# ADDENDUM No.1

## Town of Plattsburgh – Battlefield Memorial Gateway Park Site Development - Phase I

March 6, 2023

Elan Project No.: 20-015.8

**9 MASONRY UNIT WALL**  
SCALE: NOT TO SCALE

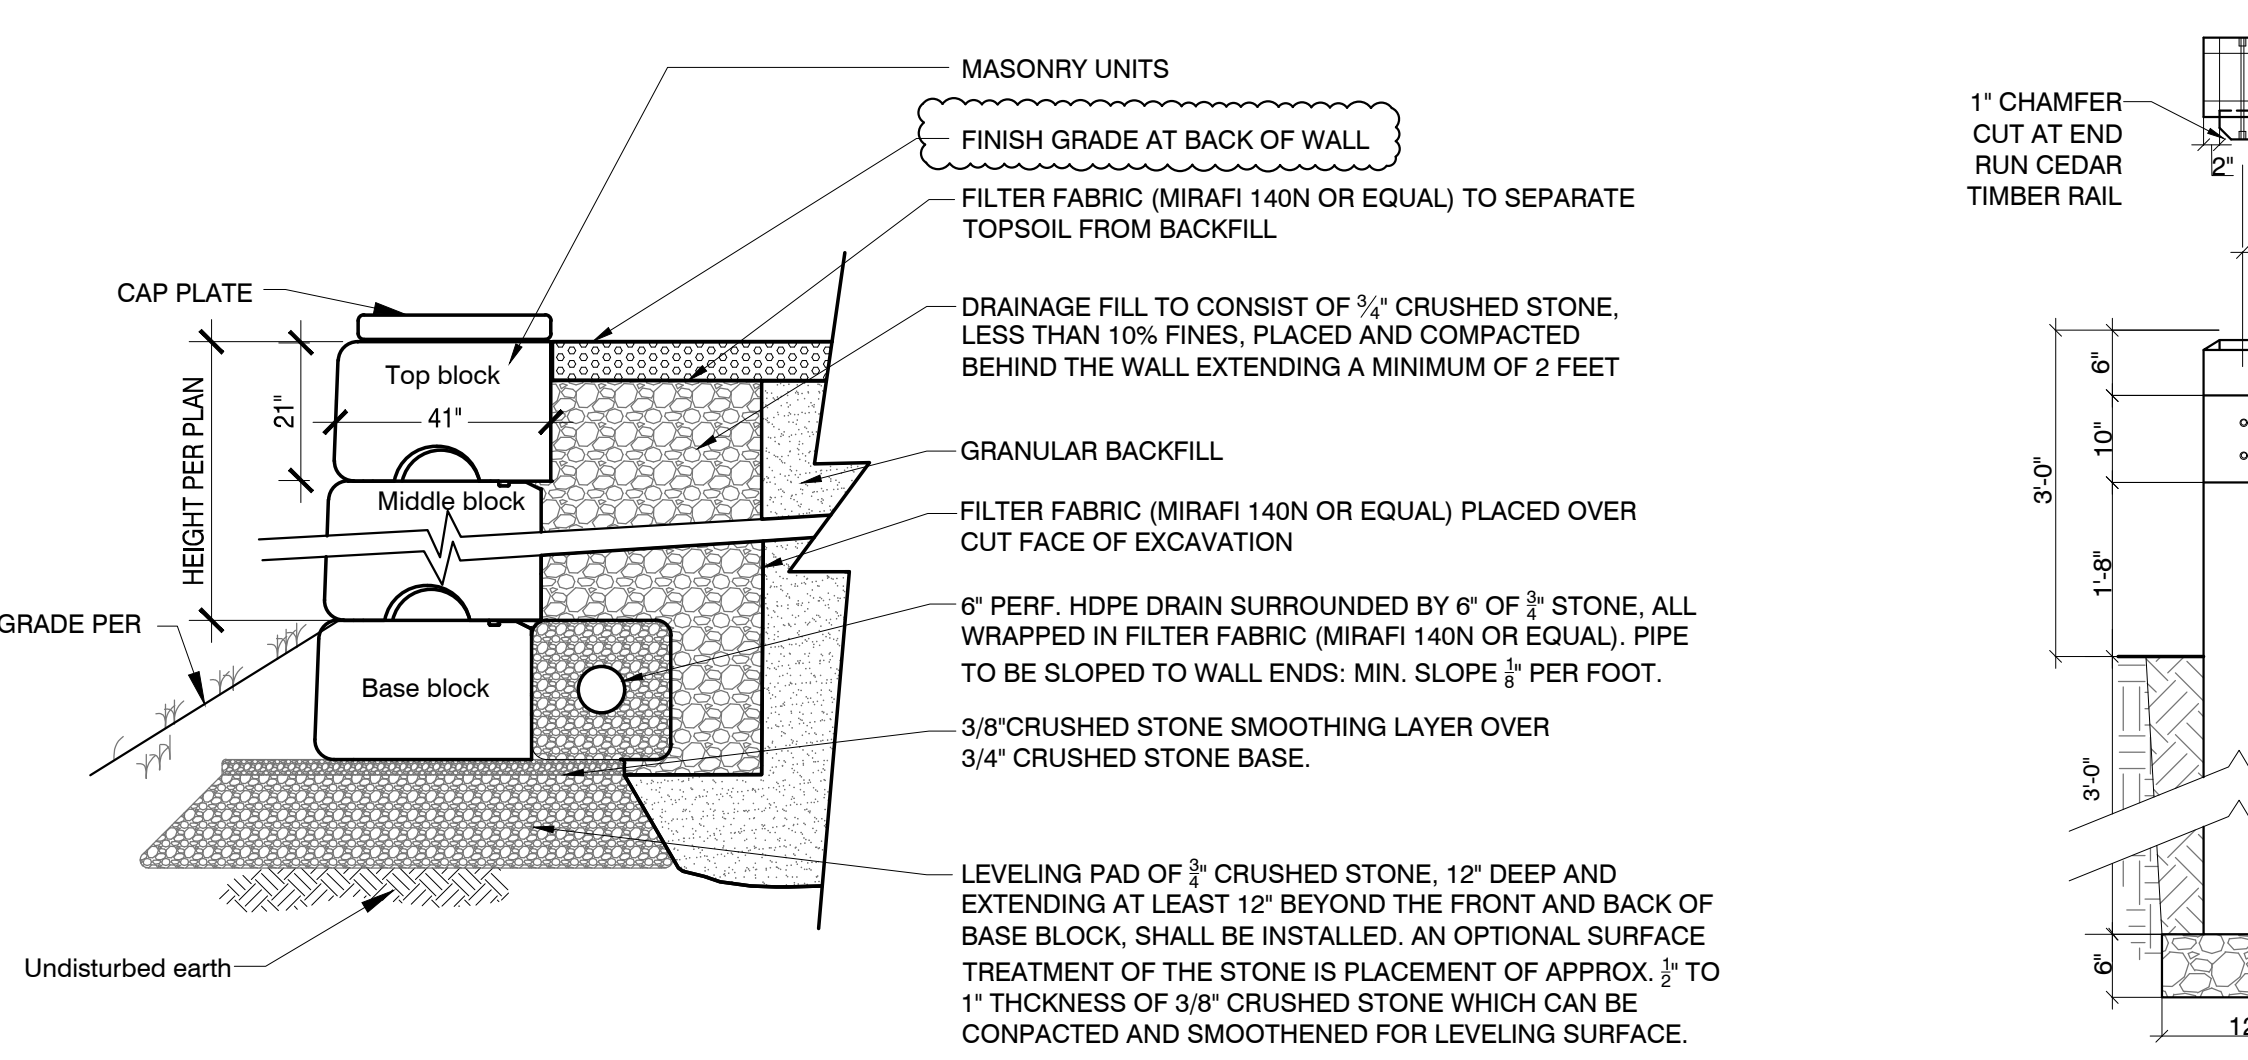
- ITEM10: In the Project Drawings entitled “Town of Plattsburgh – Battlefield Memorial Gateway Park – Phase I”, NYSDOS Contract No.: C1000931; **DELETE** Sheet C-202 Site Details **ADD** Sheet C-202 Site Details with revision to Detail #09 and Detail #10.
-

**7 SECTION THROUGH MULTI-USE TRAIL 2 (6')**  
SCALE: NOT TO SCALE

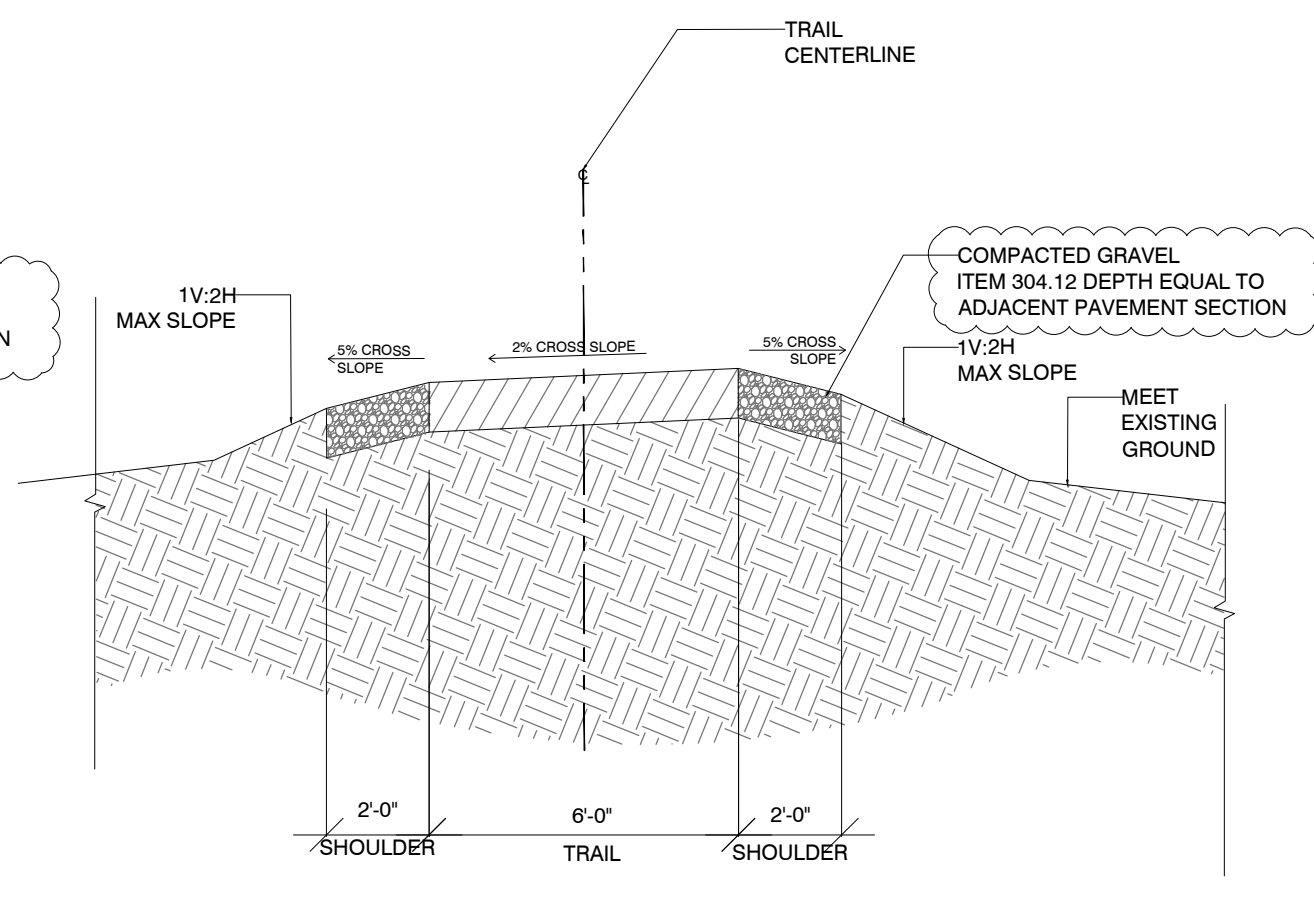
- ITEM 11: In the Project Drawings entitled “Town of Plattsburgh – Battlefield Memorial Gateway Park – Phase I”, NYSDOS Contract No.: C1000931; **DELETE** Sheet C-203 Site Details **ADD** Sheet C-203 Site Details with revisions to Section #06 and Section #07.
- ITEM 12: In the Project Drawings entitled “Town of Plattsburgh – Battlefield Memorial Gateway Park – Phase I”, NYSDOS Contract No.: C1000931; Sheet C-203 Site Details Section #07 – Section Through Multi-Use Trail 2, the width of Multi-Use Trail 2 may be increased to 8’ throughout.
